FIELD CHANGE ORDER	NUMBER: DS-630Q4-F001
--------------------	-----------------------

PROBLEM & SYMPTOM: Cross-talk problem between Dispatcher cable and switched cable. Revision incompatibility problem between M7764-00 and M7763-00 module
(Continued on Page 3)

FCO DS-630Q4-F001

INTERCONNECTION OF MIRA MODULES (SYSTEM A only is shown)

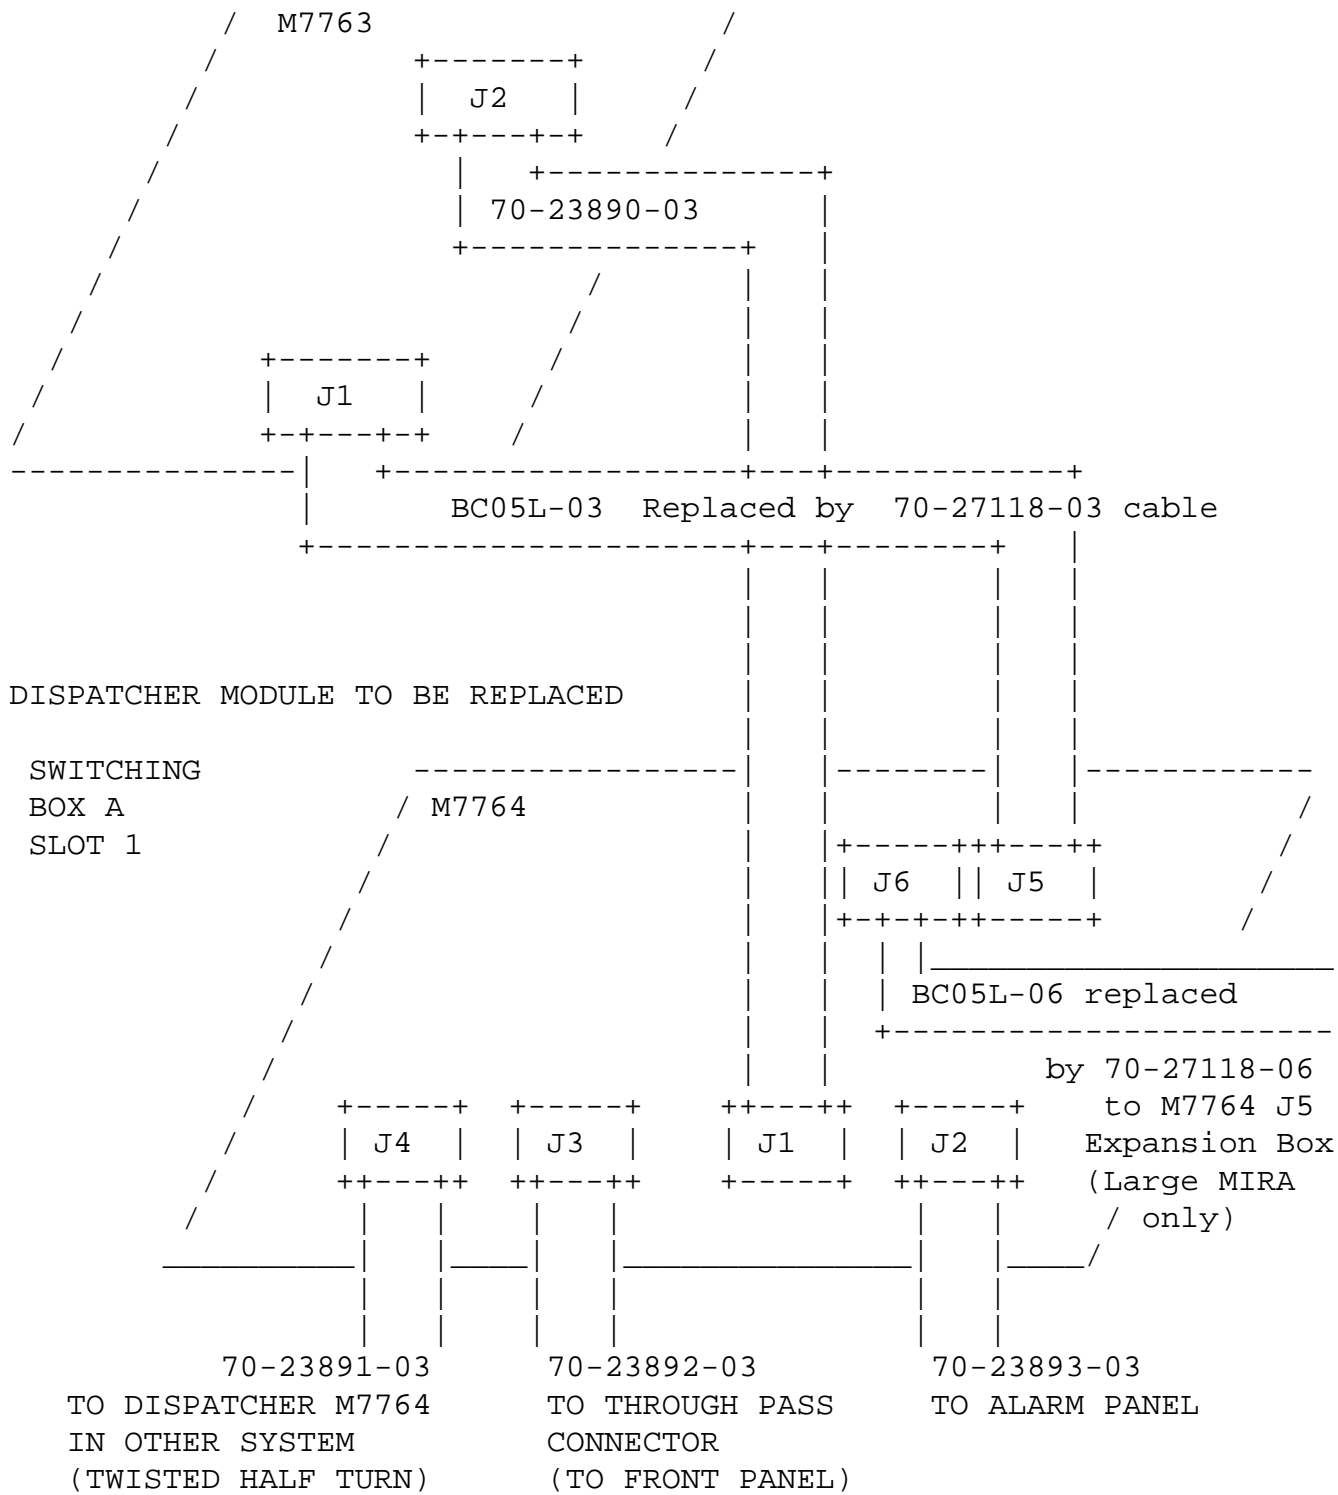
WATCH DOG MODULE TO BE REPLACED

COMPUTER A
CPU BOX SLOT 3

This FCO replaces all watch-dog, dispatchers modules and BC05L cables attached to these dispatchers. This replacement requires the complete MIRA to be powered down.

The interconnection of the modules and cables to be replaced is shown on Page 4.
